TSG-RAN Working Group 1 meeting #10 Beijing, China January 18 – 21, 2000

Title: Timing of PDSCH

CHANGE REQUEST  Please see embedded help file at the bottom of this page for instructions on how to fill in this form correctly
25.211 CR 028 Current Version: 3.1.0
GSM (AA.BB) or 3G (AA.BBB) specification number ↑
For submission to: TSG-RAN #7    Iist expected approval meeting # here ↑   for approval for information   X   strategic   (for SMG   use only)      Form: CR cover sheet, version 2 for 3GPP and SMG   The latest version of this form is available from: ftp://ftp.3gpp.org/Information/CR-Form-v2.doc
Proposed change affects: (at least one should be marked with an X)  (U)SIM ME X UTRAN / Radio X Core Network
Source: Ericsson Date: 2000-01-14
Subject: Timing of PDSCH
Work item:
Category:FCorrectionRelease:Phase 2ACorresponds to a correction in an earlier releaseRelease 96(only one category shall be marked with an X)BAddition of featureAddition of featureWith an X)DEditorial modificationXRelease 98Release 99Release 99Release 90Release 90

Reason for change:  The relative timing between the start of a DPCH frame and the associated PDSCH frame should be increased in order to lower the

Figure 28: Timing relation between DPCH frame and associated PDSCH frame

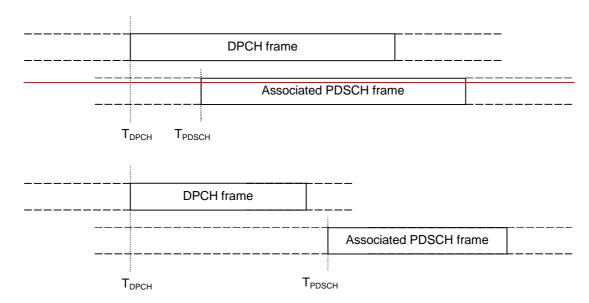
Hence, we propose a modified timing between DPCH frame and the associated PDSCH frame, where the PDSCH frame may start between 0 and 15 slot after the end of the DPCH frame. Since the TFCI is placed in the first half of the slot, this will give some time (600  $\mu$ s as a minimum) to process the TFCI before the PDSCH frame arrives at the UE.

The start of a DPCH frame is denoted  $T_{DPCH}$  and the start of the associated PDSCH frame is denoted  $T_{PDSCH}$ . Any DPCH frame is associated to one PDSCH frame through the relation—35840 chips  $< T_{DPCH}$ — $T_{PDSCH} \le 2560$  chips = 38400 chips  $= T_{DPCH} < 76800$  chips, i.e. the associated PDSCH frame starts anywhere between the end of the DPCH frame1 slot before or up to 154 slots behind the end of the DPCH frame.
